**RAIB Report: Fatal accident at Bayles and Wylies footpath crossing,
Bestwood, Nottingham, 28 November 2012**

I write to report¹ on the consideration given and action taken in respect of the recommendations addressed to ORR in the above report, published on 26 September 2013.

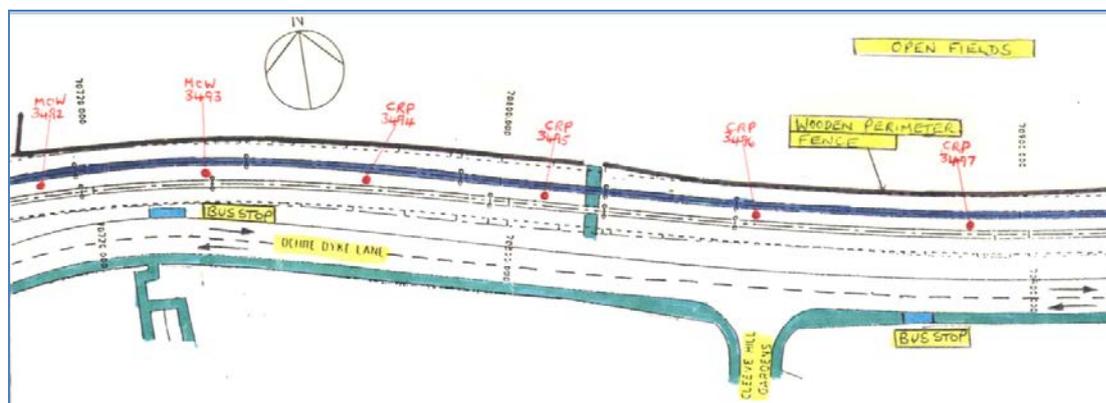
NXMM has prepared a capital programme of works to resolve the identified installation issues on its segregated pedestrian crossing infrastructure. This work is due to commence on 12 May and will continue for a period of 5 weeks. Upon completion of this programme, all NXMM pedestrian crossings shall be compliant with the relevant guidance.

Further works to provide markings to the crossing boundaries as detailed in paragraph 96 (ii) of the RAIB report will continue to be considered in conjunction with other system operators and within the context of UK Tram as part of its working group 3a, which is considering the tram/pedestrian interface. This group's work is currently on-going and any identified improvements will be adopted as appropriate.

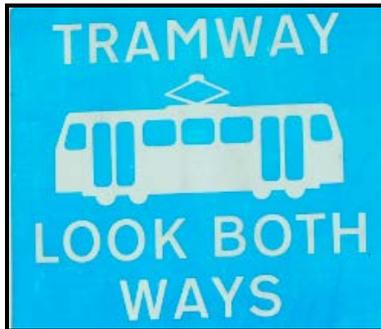
A full review of our route risk assessments has been carried out in order to establish any areas that required further review. This identified a pedestrian crossing crossed by segregated tramways where the tram speed is 40mph outbound and 30mph inbound.

This is an access path and although not a designated cycle path it is used by cyclists and currently there are no barriers in place.

Due to this being classified as an access road we are currently in talks with the Sheffield City Council in order to agree what form of barriers, if any could be installed and if there is an alternative access point available for the tractor that uses it for access to the fields adjacent to the tramway. Timescales for update on this is 31st December 2013, with a view to have a solution in place early 2014. There is appropriate signage at this crossing to advise pedestrians of the tramway risks.
